Columbia River Crossing Project  
C/O Heather Gundersen, Environmental Manager  
700 Washington Street, Suite 300  
Vancouver, WA 98660

**SUBJECT: URBAN DESIGN ADVISORY GROUP COMMENTS TO THE DRAFT  
ENVIRONMENTAL IMPACT STATEMENT**

DRAFT -Design Guidance for the Columbia River Crossing Project

#### 3.2.1 Marine Drive Interchange

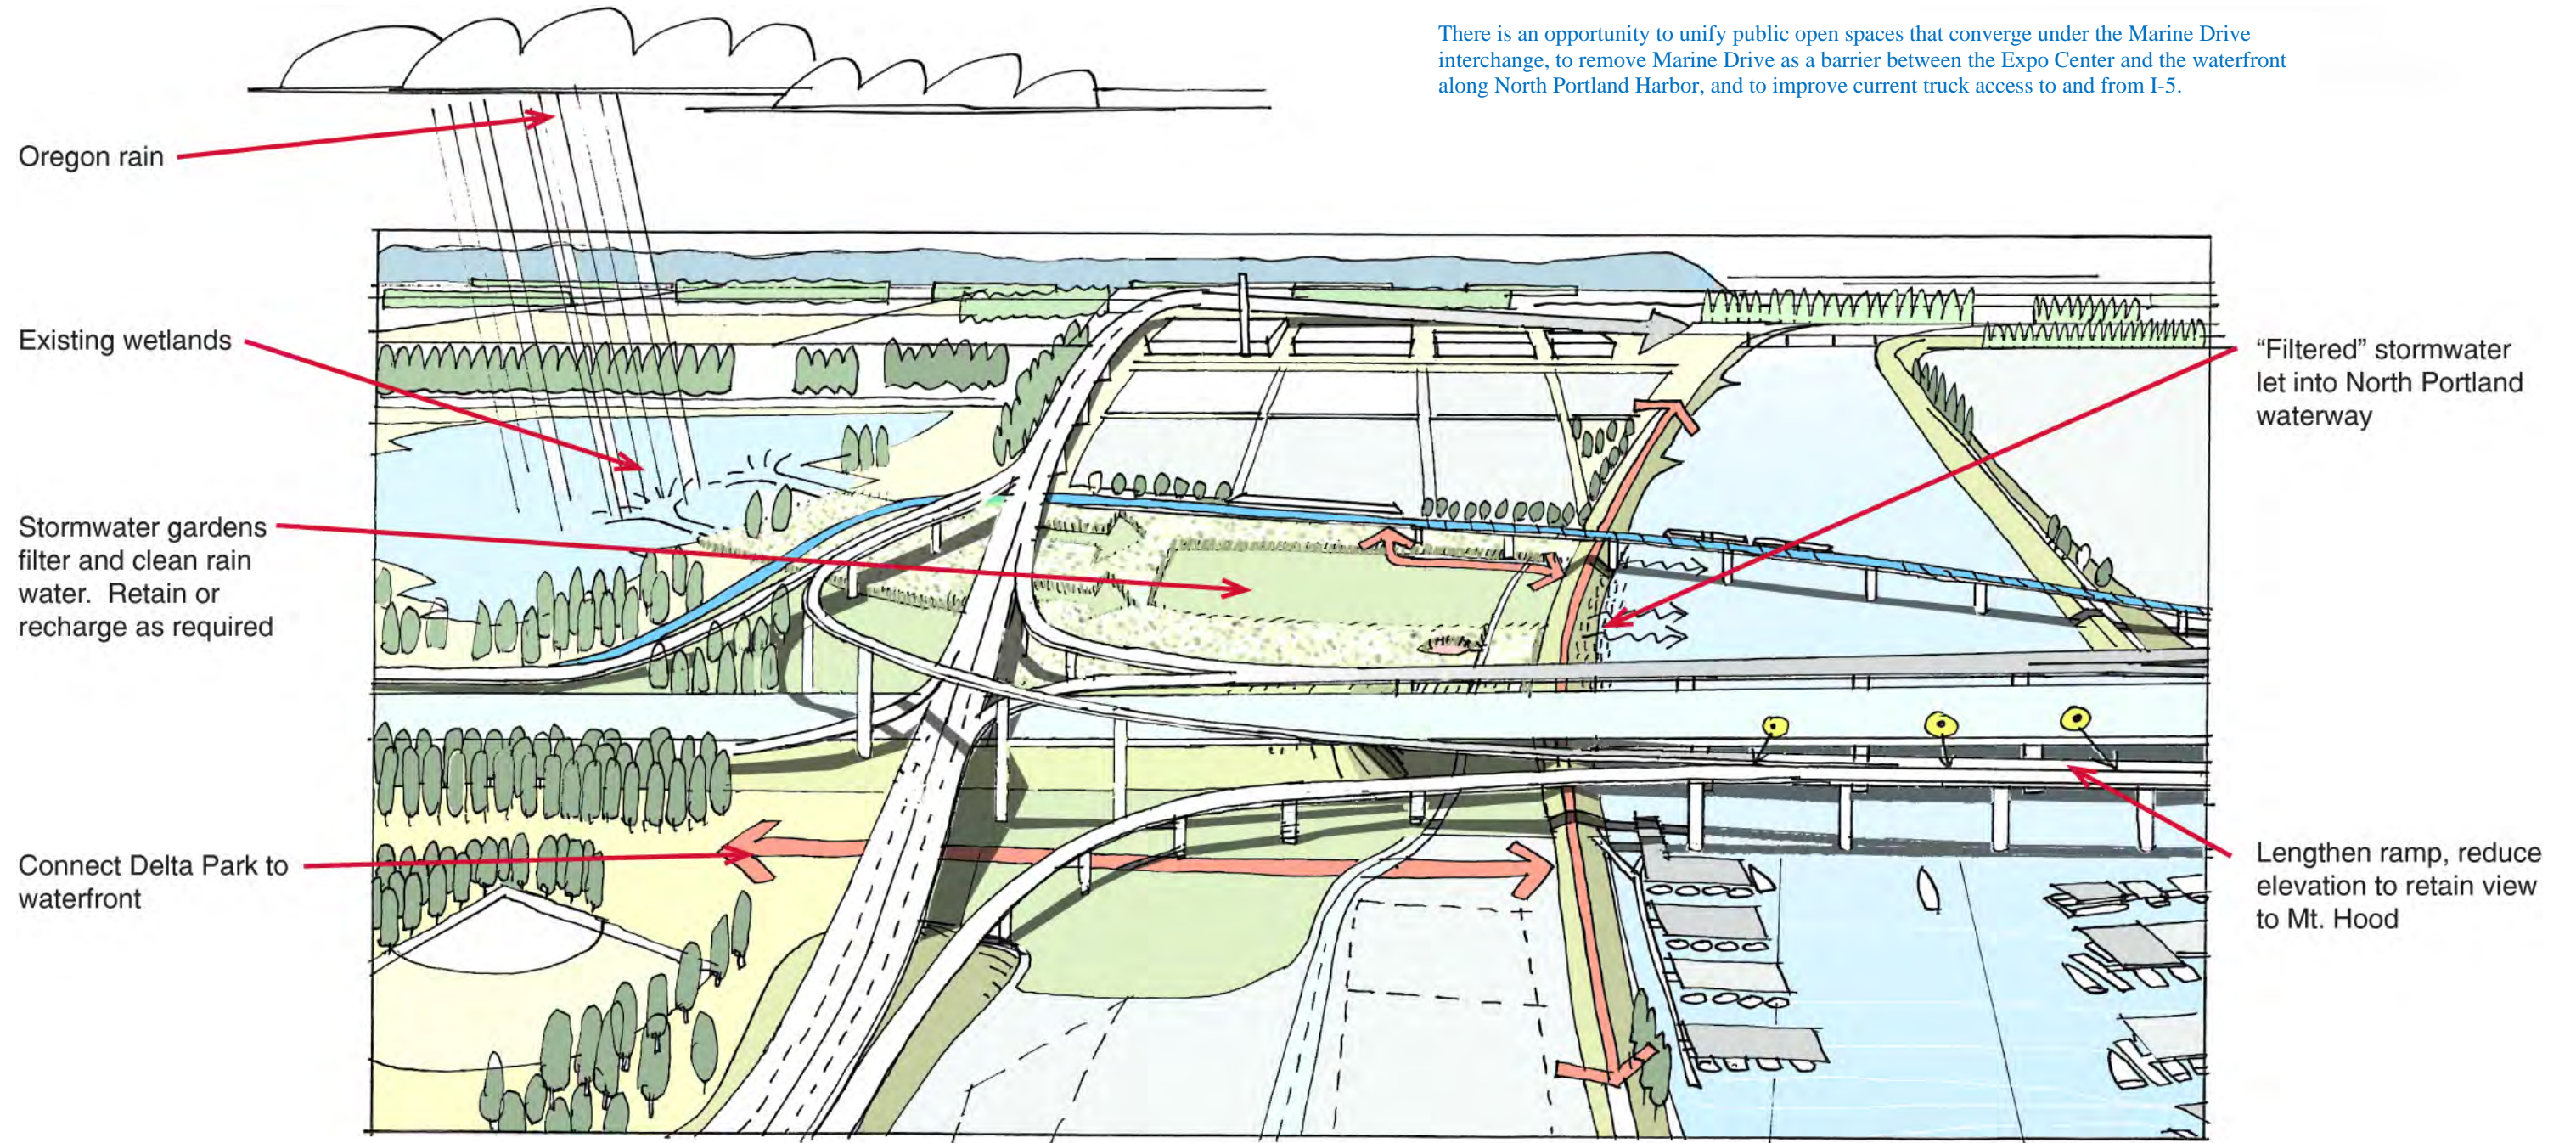
1. Investigate alternative reconfigurations of the Marine Drive intersection to vacate waterfront land for public and development uses, to improve ramp geometry and to improve interconnection of green spaces that converge at the interchange. *Improve waterfront access and interconnect adjacent spaces.*

3. Configure and design green space under the Marine Drive intersection structures to interconnect an expanded Delta Park to the Expo transit station and to open spaces to the southwest and along the North Portland Harbor. *Interconnect open spaces under the interchange.*

4. Integrate direct and safe bicycle and pedestrian circulation trails through and between these spaces. *Create a local access network.*

**Exhibit 3-1. North Portland Harbor Crossing**

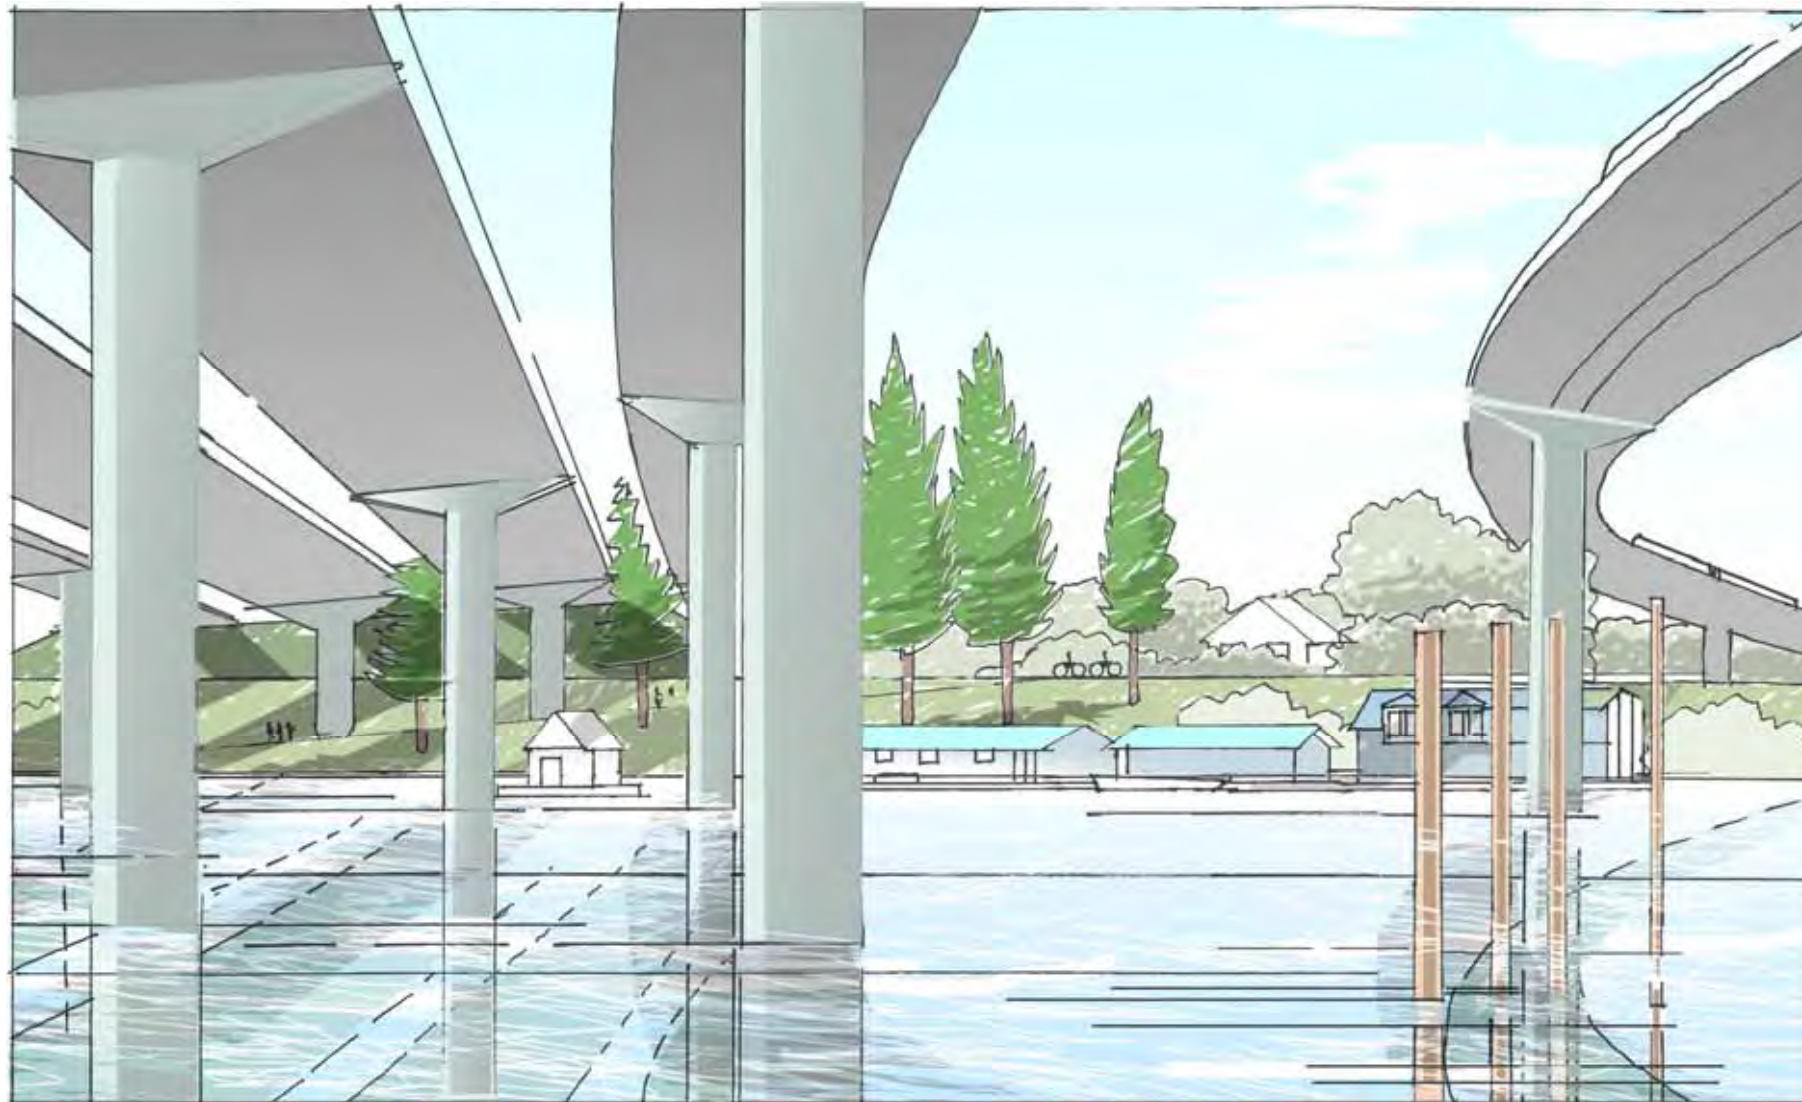
5. Improve pedestrian and bicycle access along the south bank of the North Portland Harbor under the highway with adequate headroom and lighting, thus connecting Bridgeton to the 40-mile loop. Provide safe and convenient access to the Expo transit station. *Improve waterfront trails.*
6. Minimize piers in North Portland Harbor and consider bridge types independent of the constraints that shape the bridge over the Columbia River. *Consider other bridge types with fewer columns in the water.*
7. Construct the highway ramp and transitway spans over the North Portland Harbor as light and elegant bridges. Their architecture need not reflect that of the main highway spans. *Make detached bridges light and elegant.*
8. Preserve highway views towards Mount Hood. *Preserve views to Mt. Hood.*

#### Exhibit 3-3. Hayden Island LRT Station and I-5 Crossing

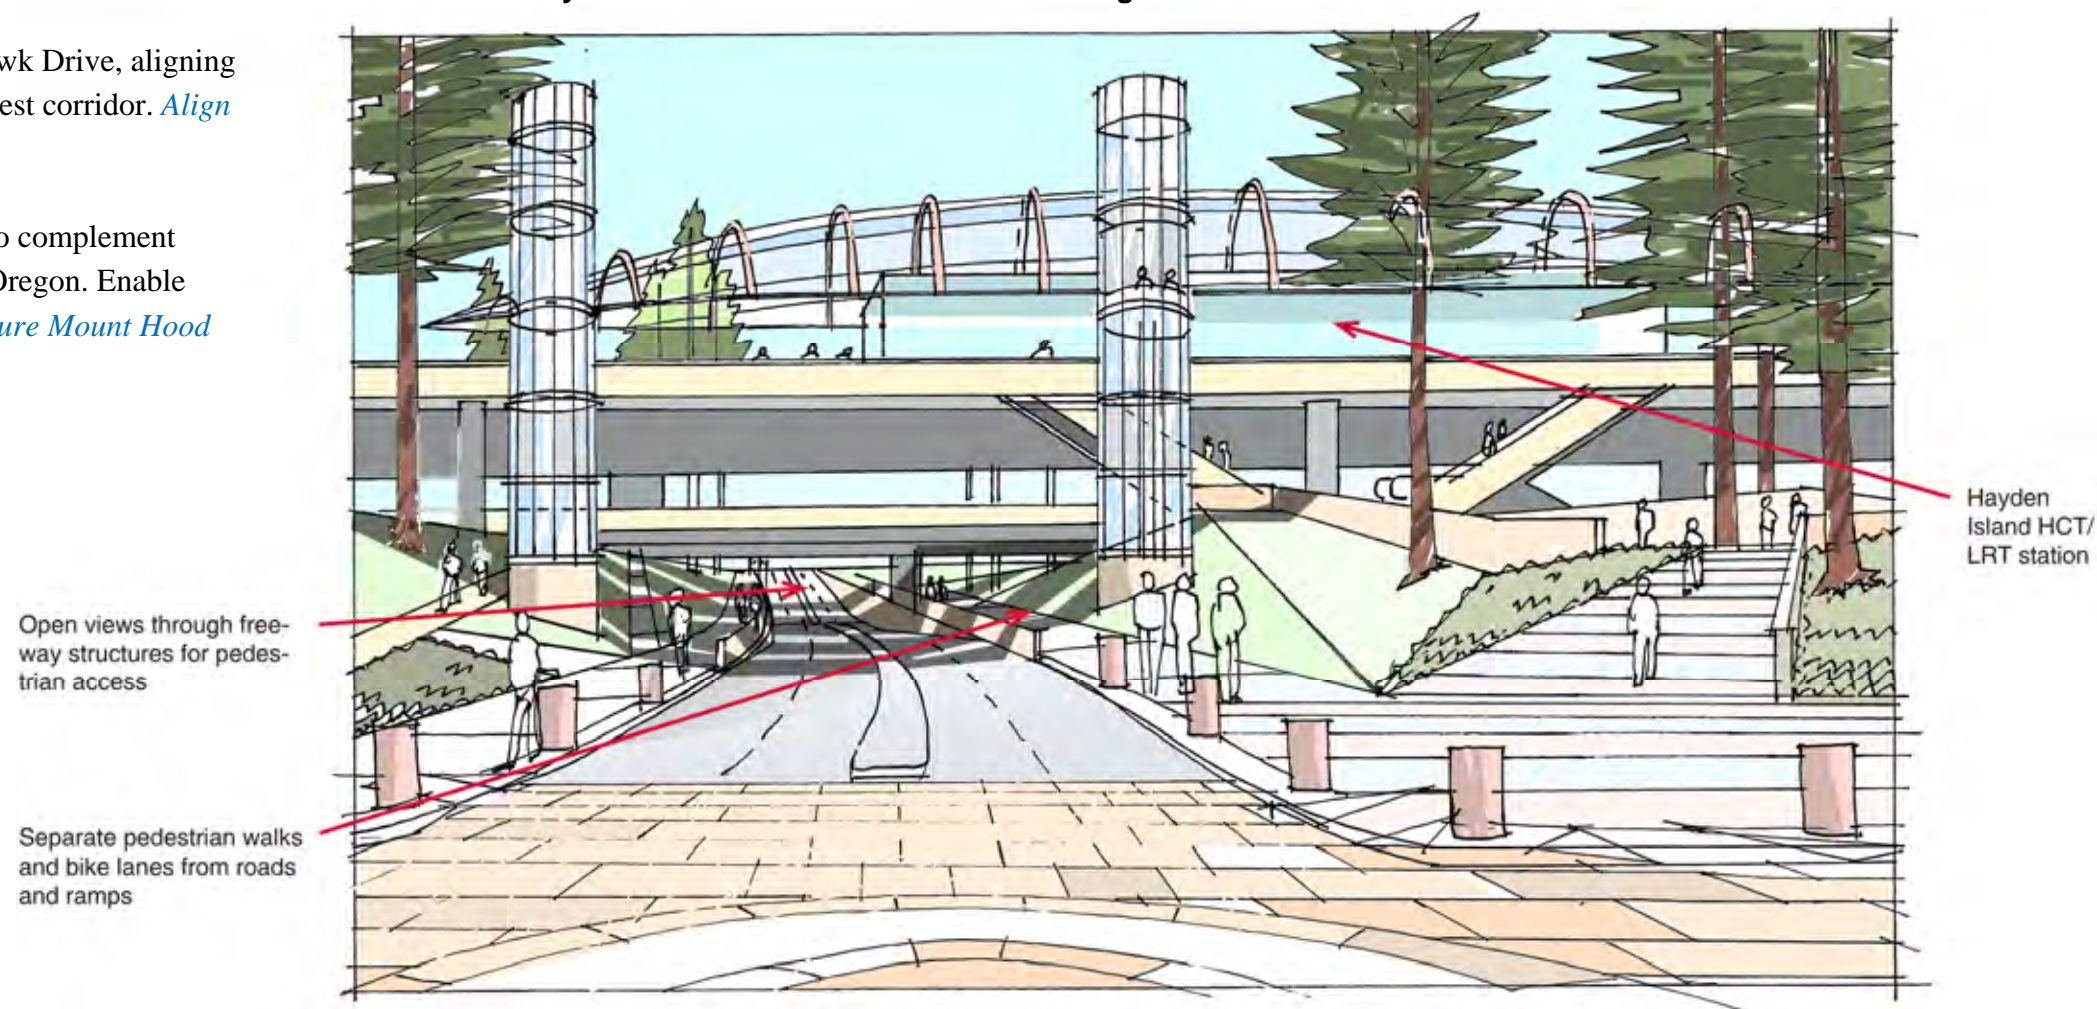
11. Locate the station directly above Tomahawk Drive, aligning access and landscape with the planned east-west corridor. *Align transit station with Tomahawk Drive.*

12. Design the Hayden Island transit station to complement features that announce arrival in the state of Oregon. Enable views of Mount Hood from the platform. *Ensure Mount Hood views from transit platform.*

13. Locate transient boat docks under the highway on the north and south sides of North Portland Harbor and on the north side of Hayden Island to facilitate public boat access. *Locate boat docks for visitors under the highway.*

14. Plan for future addition of a local traffic, bicycle and pedestrian bridge across North Portland Harbor east of the highway, location to be determined (This is not seen as part of the

15. Increase separation between ramps at the Hayden Island interchange to enable creation of generously planted landscaped terraces. Use this landscape also for natural treatment of storm-water runoff. Design noise walls and berms integral with the interchange to reduce noise trespass to the east and west. *Space ramps to admit daylight and generous landscaping.*

Exhibit 3-5. Columbia River Spans

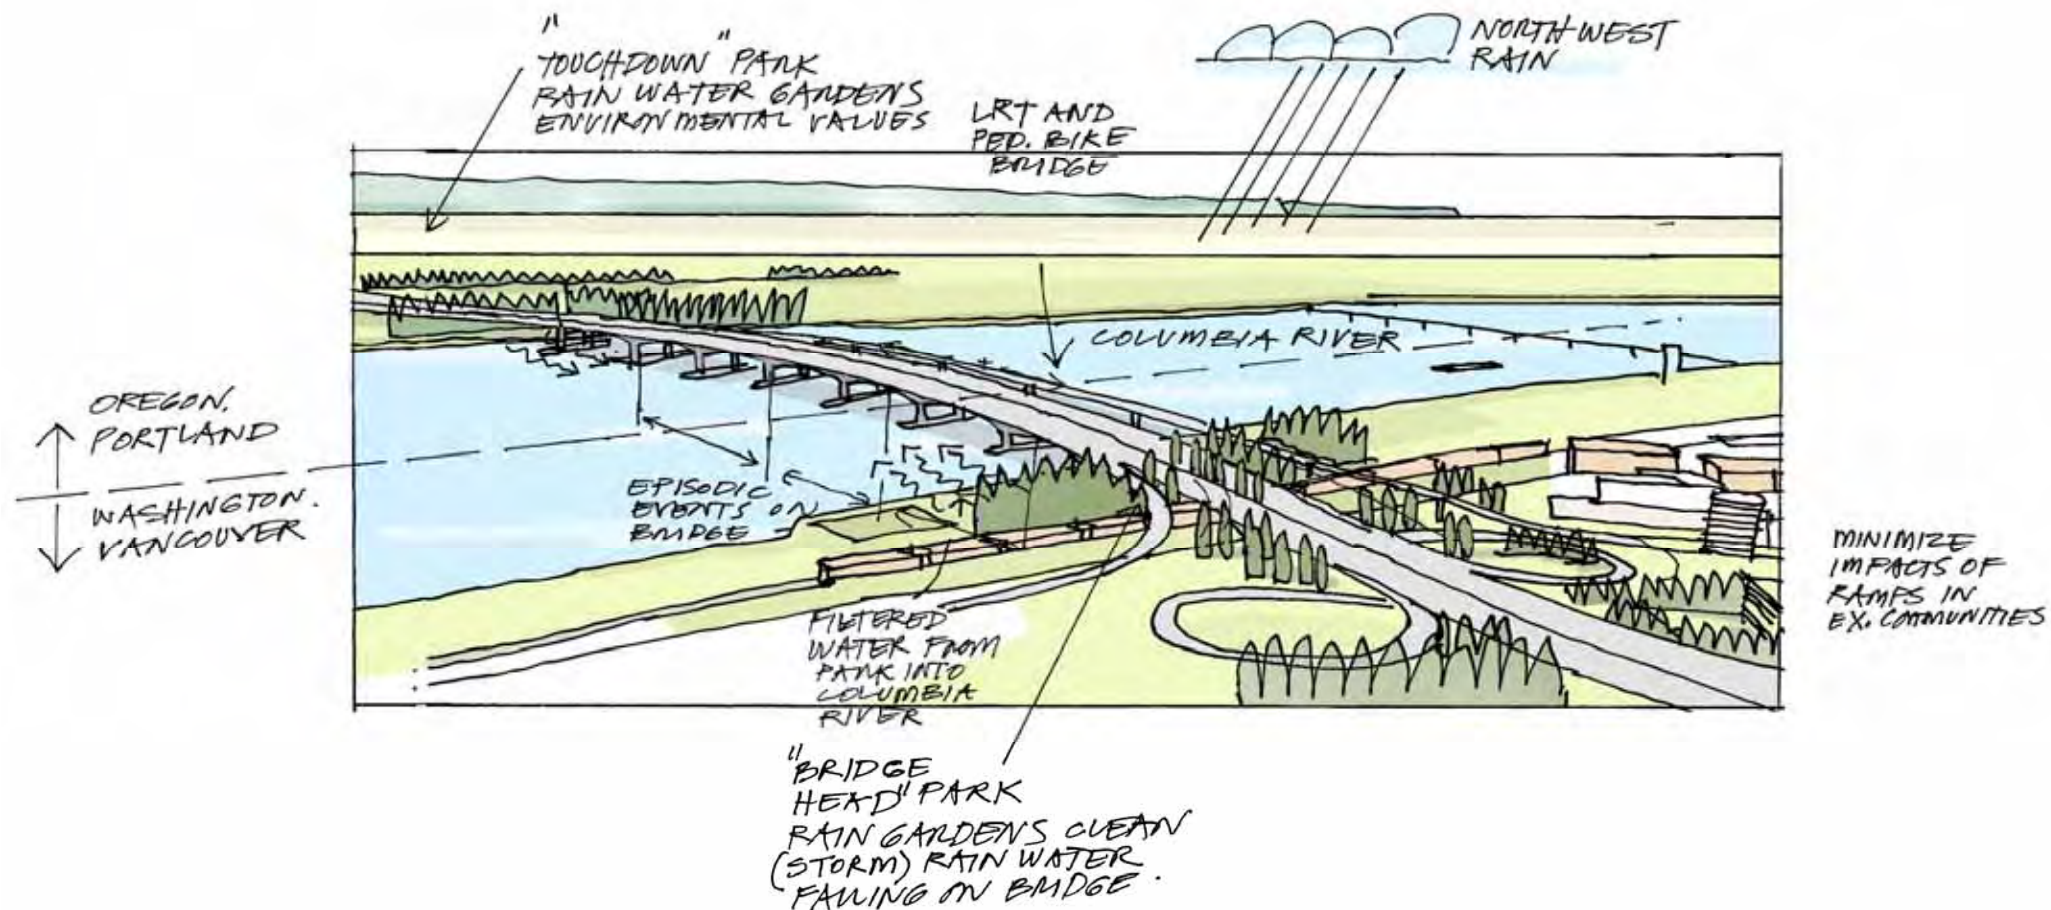
16. Members of the UDAG recommend that the FAA be approached to consider a greater height allowance for the north end of the CRC span, permitting consideration of bridge types other than girder and box-girder. (It has been suggested that an element of interpretation by FAA staff has been involved in setting the imaginary surface height restrictions, and that a different interpretation might change the limits on bridge type). *Challenge aviation height limits.*

21. Consider design opportunities on the south parts of the span that are relatively unconstrained in height. (FAA height limitations related to Pearson Field have effectively reduced bridge type selection to a single choice: box girder bridge. This might suggest a non-symmetrical bridge design or inclusion of an iconic object associated with the river crossing. Astoria Bridge demonstrates use of two distinct bridge types, one of limited height, the other much higher. Such options do not appear to have been considered for CRC). *Consider other bridge types south of the Pierson Airfield constraints.*

22. Use landscape and controlled views to build anticipation of the river crossing in those approaching the main span. *Design dramatic approaches to the river crossings.*
